**Site Characterization and Focused Feasibility Study Work Plan for the
RVAAP-51 Dump along Paris-Windham Road**

**Ravenna Army Ammunition Plant
8451 State Route 5
Ravenna, Ohio 44266**

**DRAFT SITE CHARACTERIZATION AND FOCUSED FEASIBILITY STUDY WORK PLAN
FOR RVAAP-51 DUMP ALONG PARIS-WINDHAM ROAD
AT THE RAVENNA ARMY AMMUNITION PLANT, RAVENNA, OHIO
COMMENT RESPONSE TABLE – ADDITIONAL COMMENT RESPONSE MEETING (CRM) CHANGES
REV. 2, 7-JUNE-2010
(ADDITIONAL OR REVISED TEXT CHANGES FROM CRM ARE INDICATED BY BLUE BOLDED TEXT)**

Figure 3-2. Sample Location Map

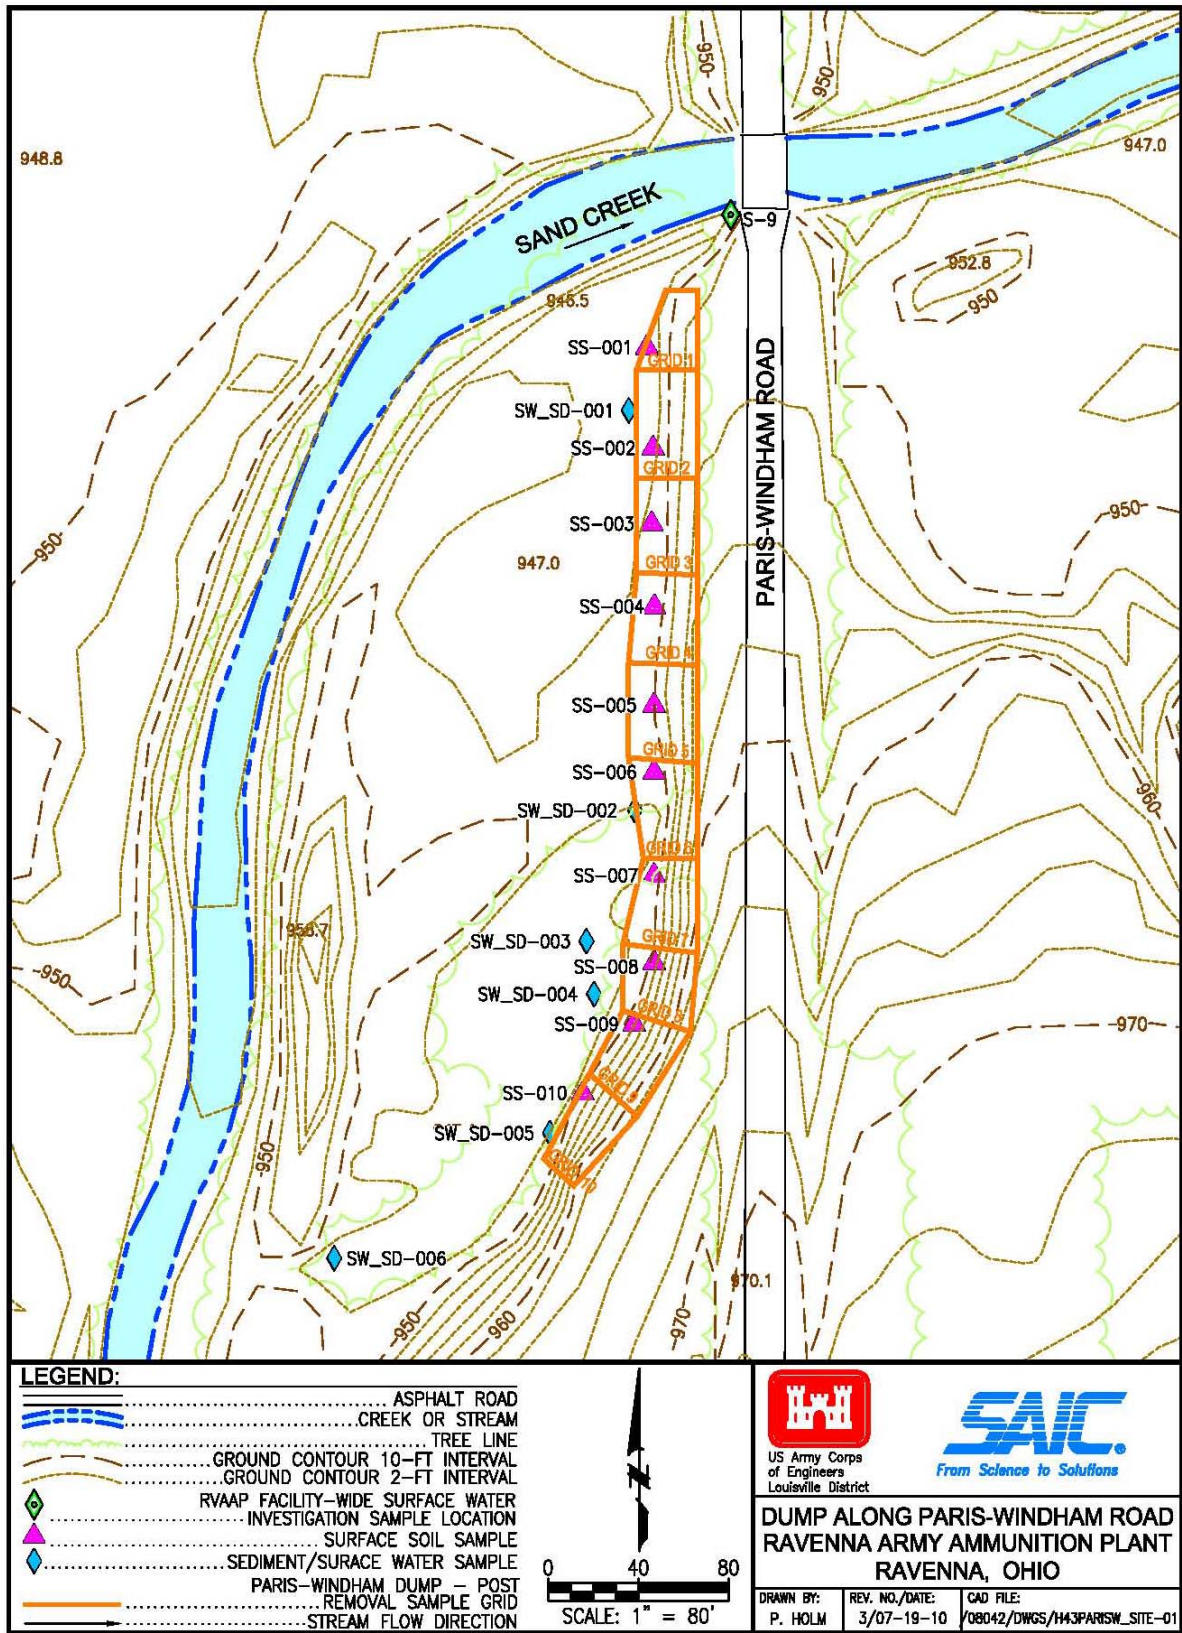
O-10	Page 3-7, Figure 3-2	Pg 3-7	There is no discussion of the Ecological Sample in the text preceding this figure.	Please add a discussion in the text or remove ecological sample location from the figure.	<p>Agree. The ecological sample location has been removed from the figure.</p> <p>Per the 23-February-2010 comment response meeting, Figure 3-2 will be retained in the Work Plan and Facility-Wide Surface Water Investigation sample station S-9 will be retained on the figure. However, the legend of Figure 3-2 has been revised to indicate that station S-9 is a RVAAP Facility-Wide Surface Water Investigation sample station.</p>
O-11	Page 5-2 Figure 5-1	Pg 5-2 Figure 5-1	The vertical text under the column heading “Potential Receptors” is illegible.	Please correct figure.	Agree. The vertical text has been corrected to make the heading text legible. The text now reads RMS, Trespasser, Resident, Aquatic, and Terrestrial.

Figure 5-1. Preliminary Conceptual Site Model for Dump Along Paris-Windham Road (RVAAP-51)

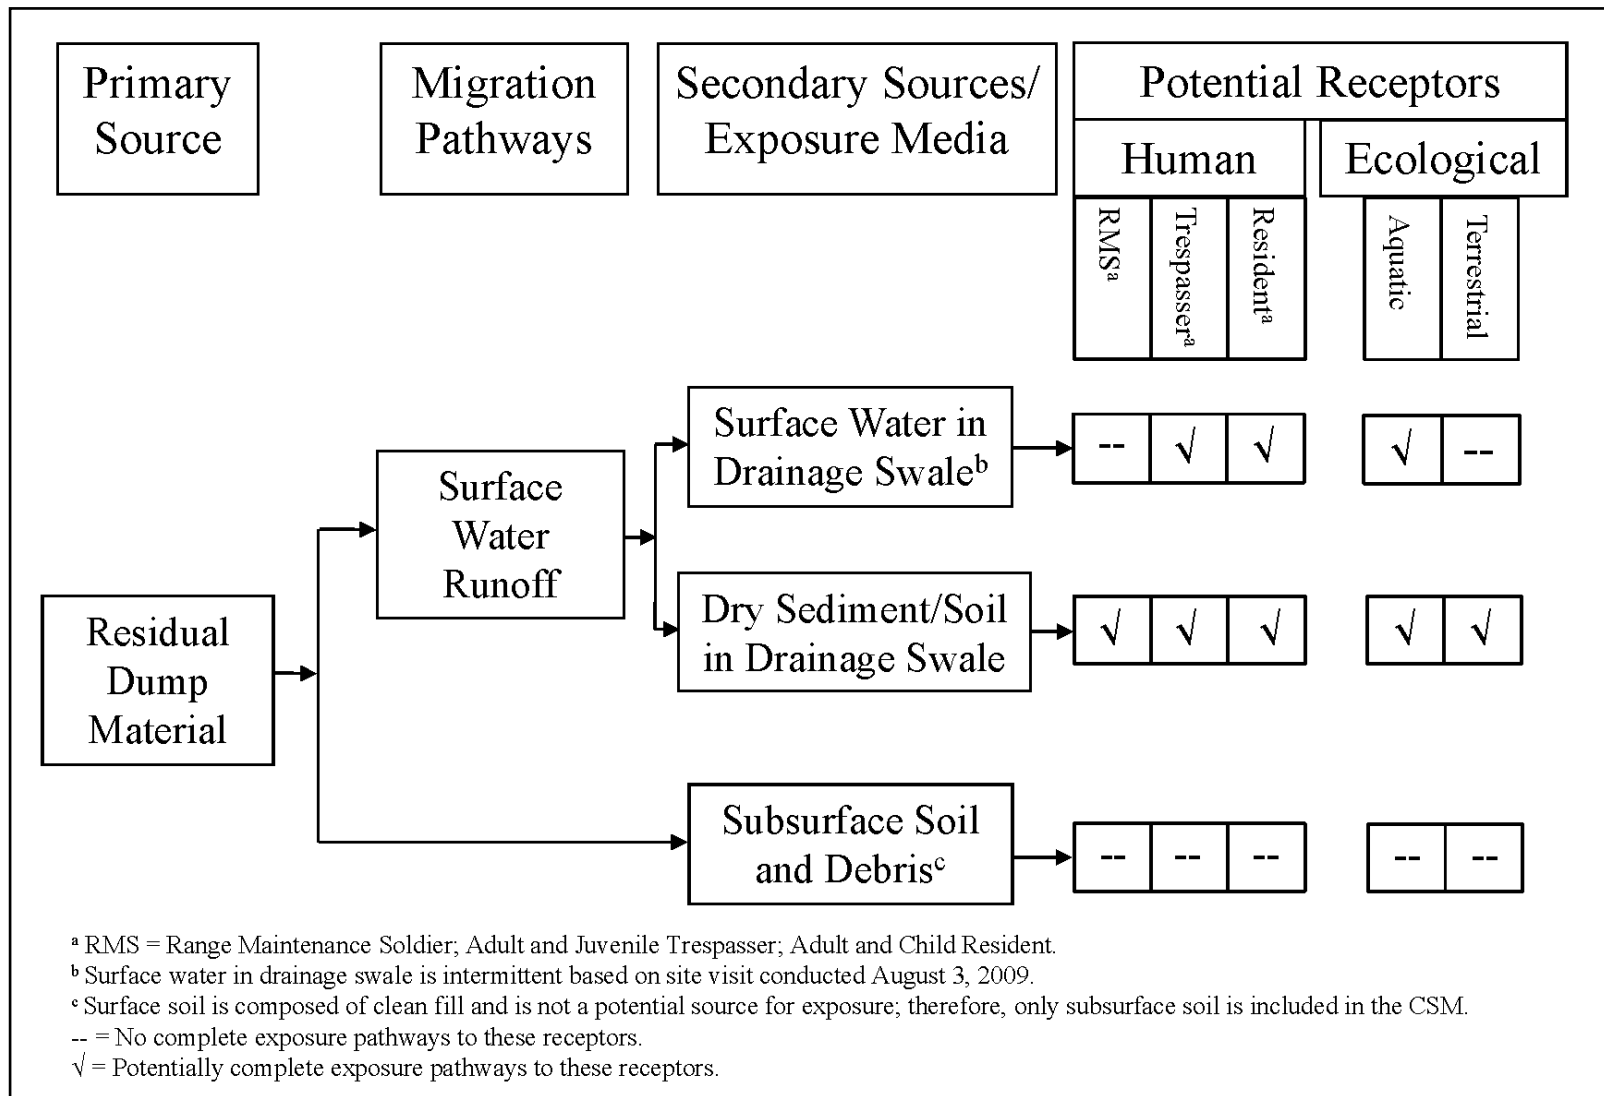
O-12	Page 5-2 Figure 5-1	Figure 5-1 Pg 6-2 Pg 6-3 Pg 7-1	The drainage swale during the August 2009 walkover contained no standing water. However, water may be present during other times of the year and not observed .	Please change pathway to show potential complete exposure pathway to receptors.	<p>Discussion requested.</p> <p>While the drainage swale periodically contains water, visual surveys during the limited “RD/RA” and again in 2009 did not indicate it was a flowing stream or perennial surface water impoundment. Based on the conceptual model, the Work Plan proposes to address sediment in the drainage swale as dry sediment based on the recent RVAAP definition for dry sediment. Clarification is requested if the swale is to be addressed as a surface water conveyance (e.g., surface water with wet sediment).</p> <p>Per the 23-February-2010 comment response meeting, surface water within the drainage swale at the toe of the AOC will not be eliminated in the Work Plan. Rather, the Work Plan will indicate intermittent surface water (and underlying sediment, classified as dry sediment) will be evaluated in the SC/FFS as a receptor with respect to exposures and potential runoff impacts to Sand Creek. The following text changes have been made:</p>

O-12 (Cont'd)					<p>Figure 5-1 has been revised to remove footnote “b” for surface water in the drainage swale and show that it is a potentially complete exposure pathway for the Adult and Juvenile Trespassers, Resident Farmer (adult and child); as well as aquatic ecological receptors.</p> <p>Section 6.1.1, 2nd paragraph, bullets 2 and 3 have been revised to indicate that the Adult and Juvenile Trespassers and Resident Farmer, (adult and child) receptors include exposure to surface water (see attached text changes at end of the CRT).</p> <p>Section 6.1.2, 1st paragraph, bullet 1 has been revised to include surface water, as well as surface soil/dry sediment as follows:</p> <p style="padding-left: 40px;">“Identify those shallow surface soil/dry sediment and surface water facility-wide CUGs that apply...”</p> <p>Section 6.1.2, 2nd paragraph, 1st sentence has been revised to state:</p> <p>“Because the drainage swale..., EPCs for shallow surface soil/dry sediment and surface water will be calculated for a single exposure unit using all of the sediment data previously collected.”</p>
